General Bid Bulletin No. 15
16 July 2021

**THE MALOLOS-CLARK RAILWAY PROJECT AND THE NORTH-SOUTH RAILWAY
PROJECT SOUTH LINE COMMUTER PACKAGE CP NS-01: PROCUREMENT OF
ELECTRICAL AND MECHANICAL SYSTEMS AND TRACK WORKS (IFB No: 21-040-3)**

PACKAGE CP NS-01: E&M SYSTEMS AND TRACK WORKS
General Bid Bulletin No. 15
Annex A

PACKAGE CP NS-01: E&M SYSTEMS AND TRACK WORKS
General Bid Bulletin No. 15
Annex B

SUBSTATION LAYOUT
(SS No. S18)

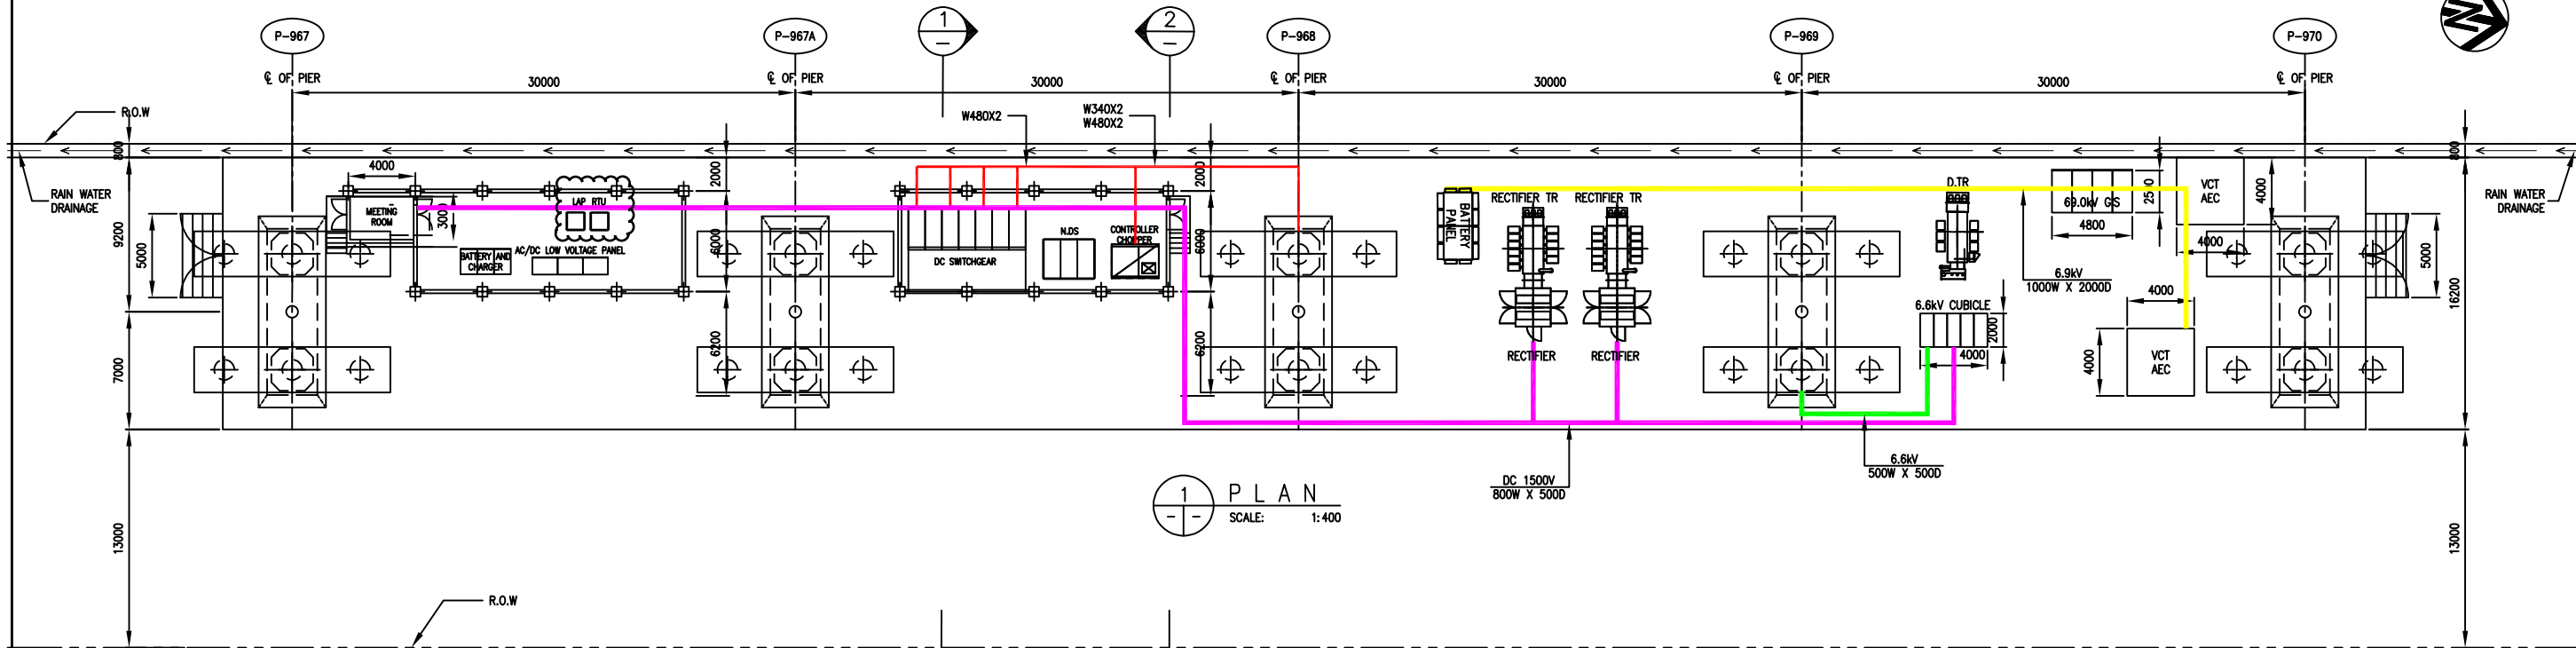
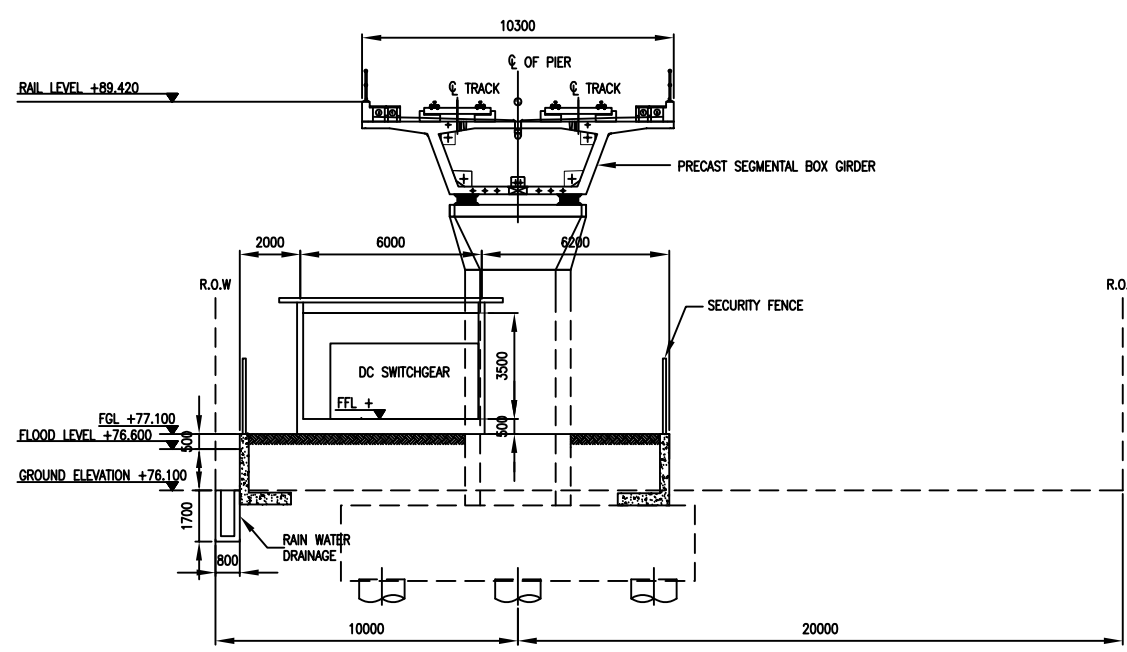
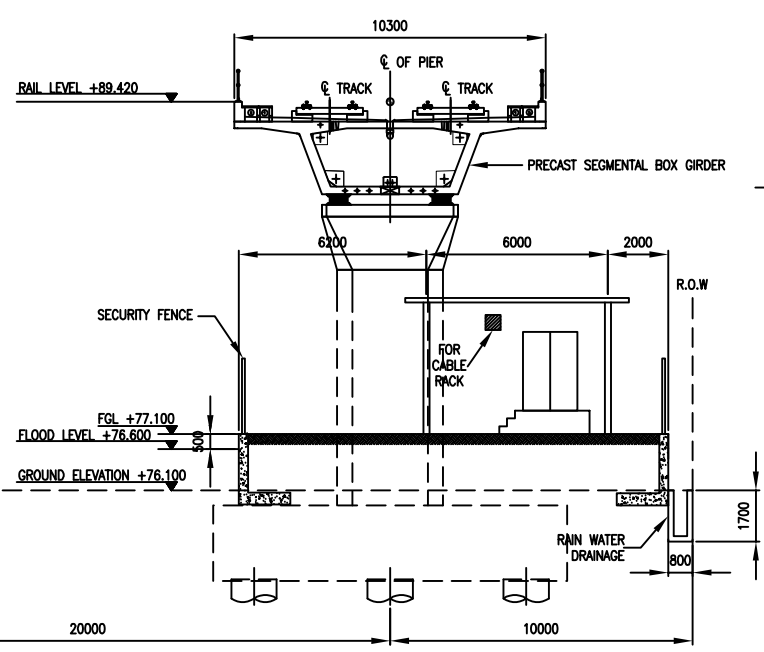
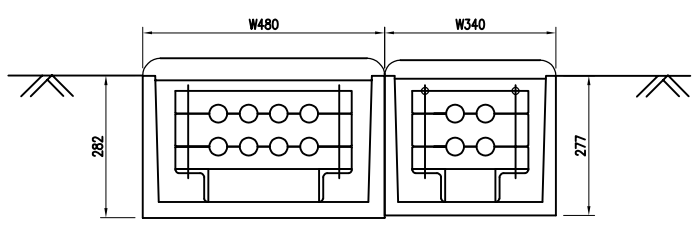
Volume III Part 2 – Employer’s Requirements d) Employer’s Drawings		
7	Part 2 Vol.3 E_M Version 11.0 FINAL Rev. A. ERD (a) page 164	Revised Traction Power Feeding System Drawing
8	GBB-9 Annex B, Item No.16	Substation Layout Drawings (SS No. 10) to (SS No. 22) “Local Annunciator Panel Added”

VERSIONS	DATE	DESCRIPTION
00	02 MAR 2021	ISSUED FOR REFERENCE
01	09 JUN 2021	RESISTOR CHANGED TO BATTERY POST
02	21 JUN 2021	LOCAL ANNUNCIATOR PANEL ADDED

MALOLOS - CLARK RAILWAY PROJECT (MCRP) NORTH SOUTH RAILWAY PROJECT-SOUTH (NSRP-SOUTH)	
Package CP NS-01 : Bidding Documents	
SUBSTATION LAYOUT (SS No. S19)

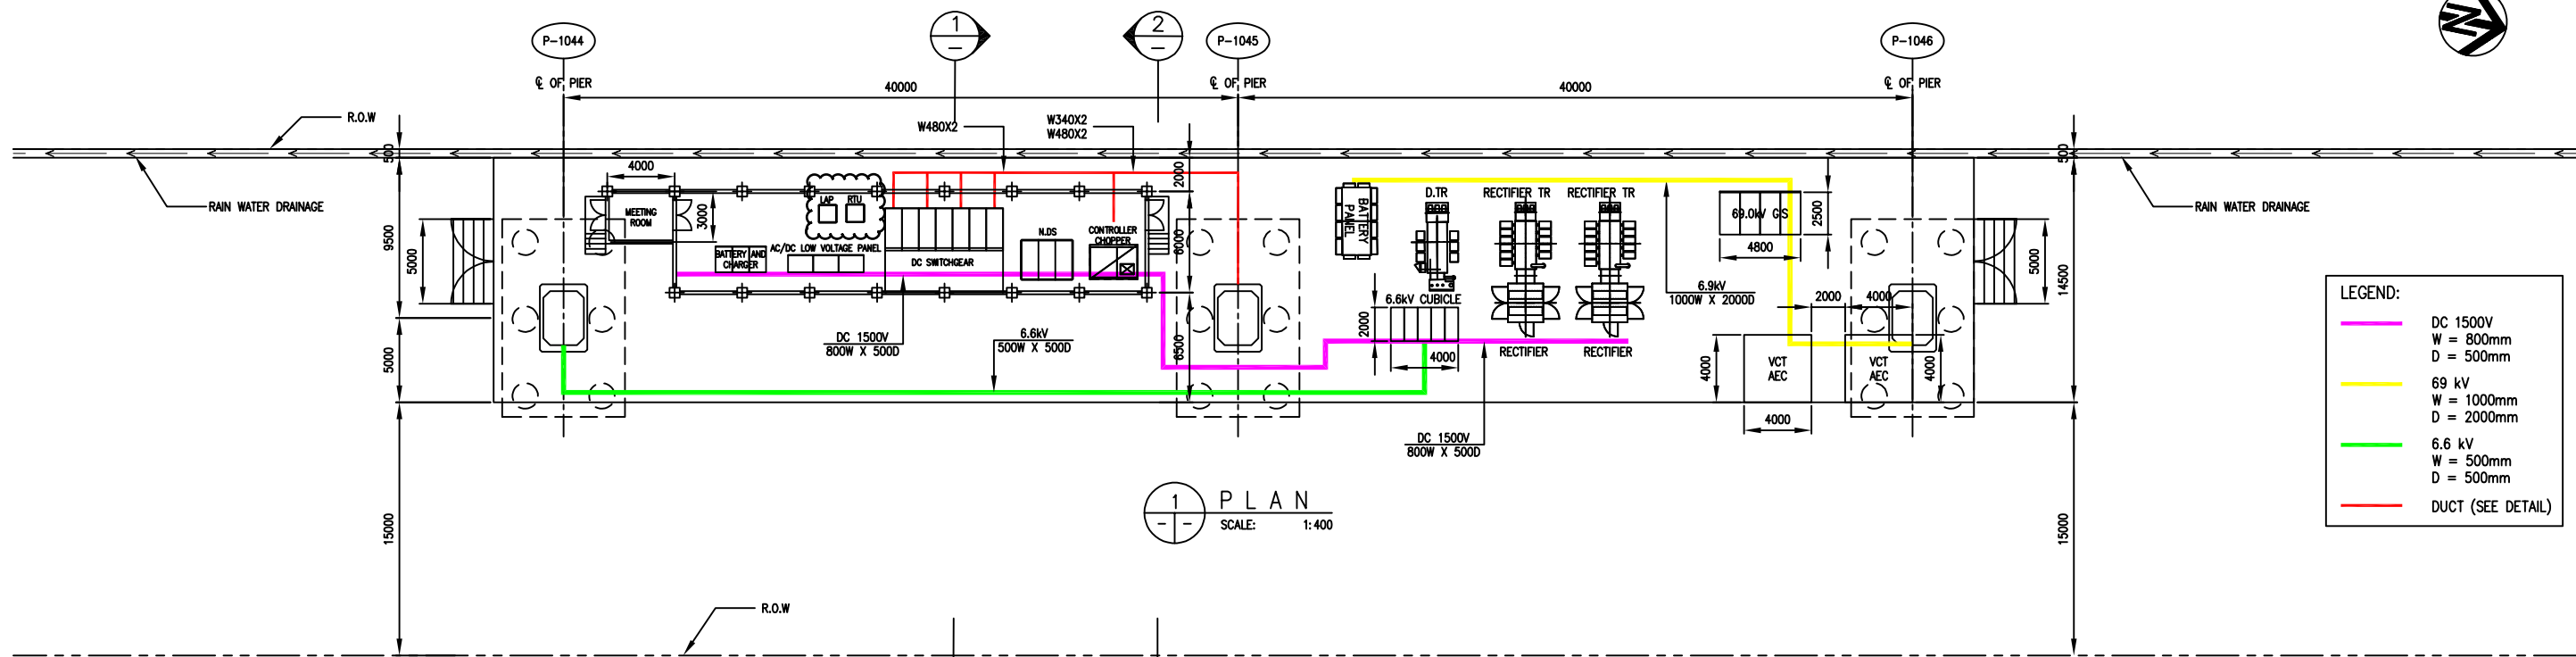
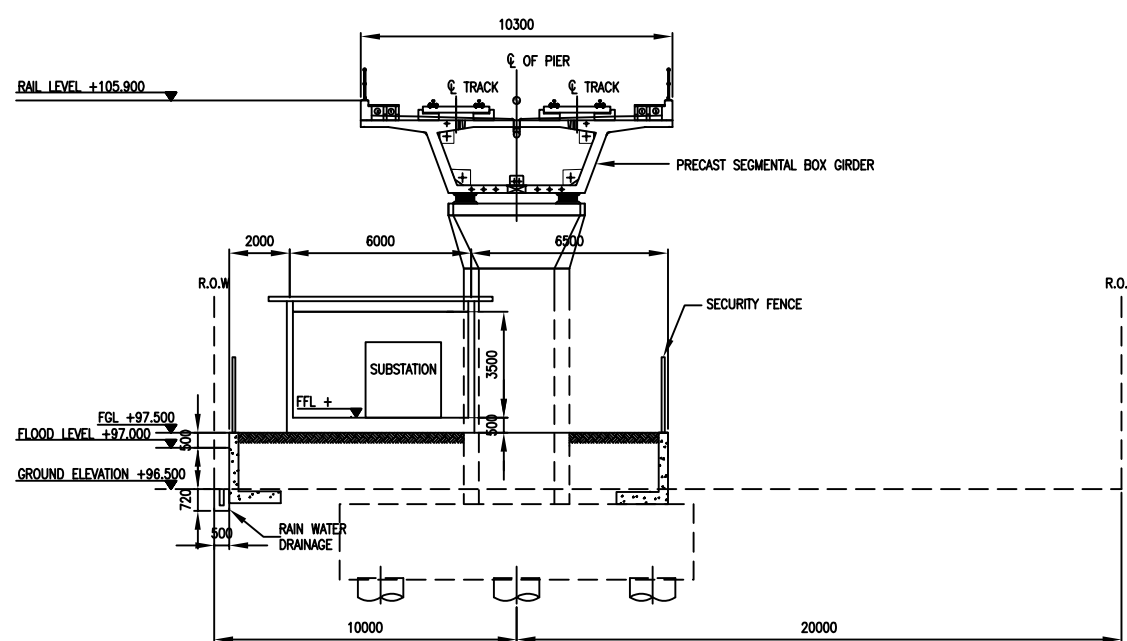
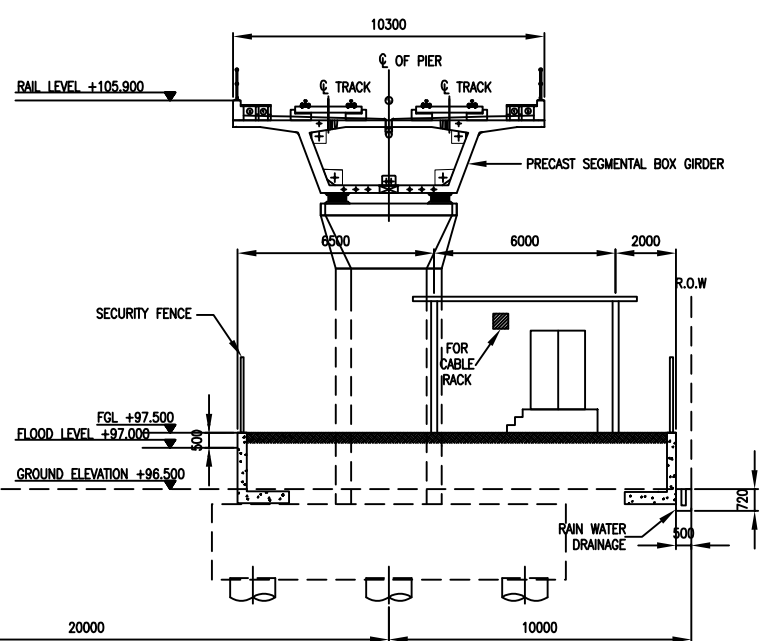
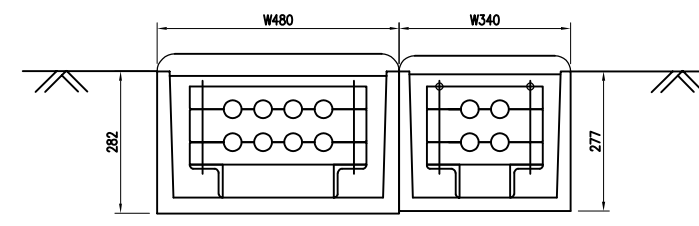
VERSIONS	DATE	DESCRIPTION
00	02 MAR 2021	ISSUED FOR REFERENCE
01	09 JUN 2021	RESISTOR CHANGED TO BATTERY POST
02	21 JUN 2021	LOCAL ANNUNCIATOR PANEL ADDED

SUBSTATION LAYOUT
(SS No. S20)

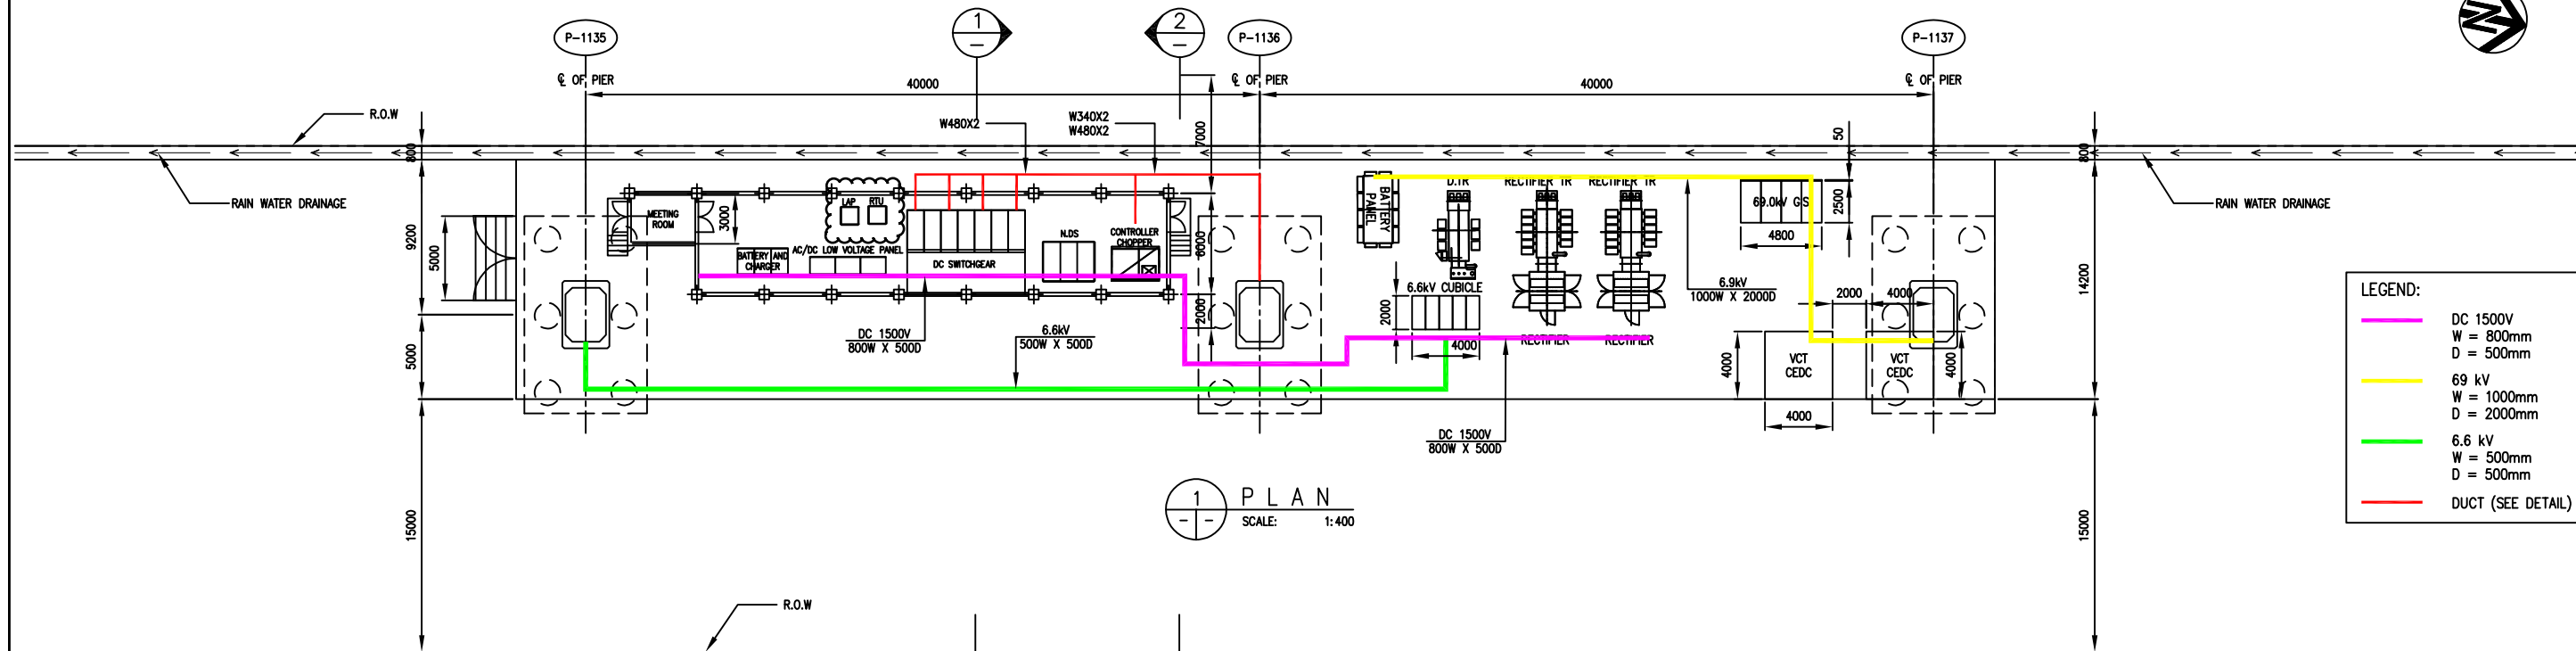
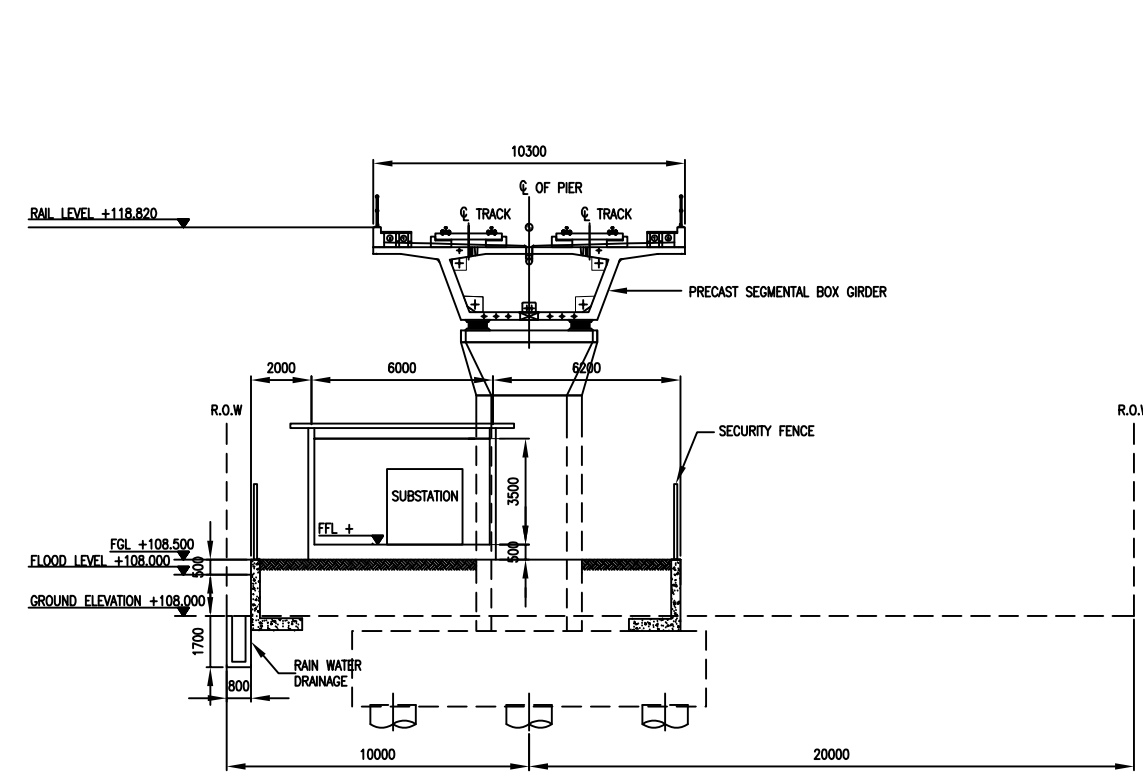
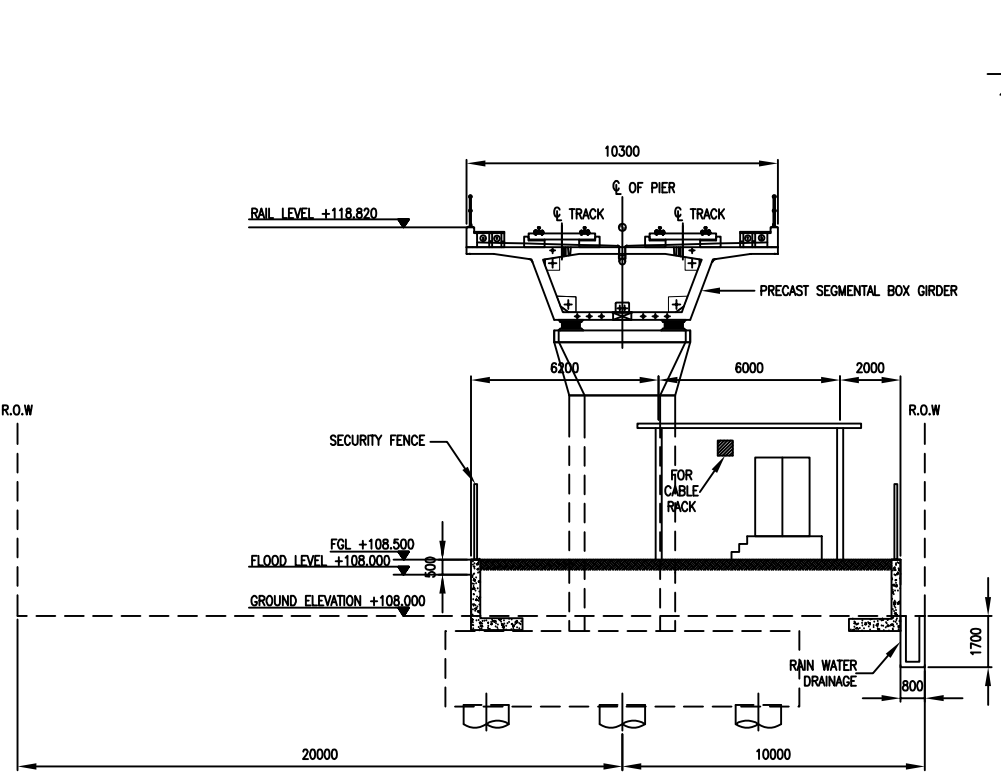
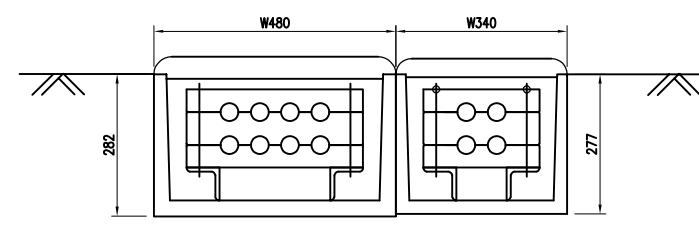
VERSIONS	DATE	DESCRIPTION
00	02 MAR 2021	ISSUED FOR REFERENCE
01	09 JUN 2021	RESISTOR CHANGED TO BATTERY POST
02	21 JUN 2021	LOCAL ANNUNCIATOR PANEL ADDED
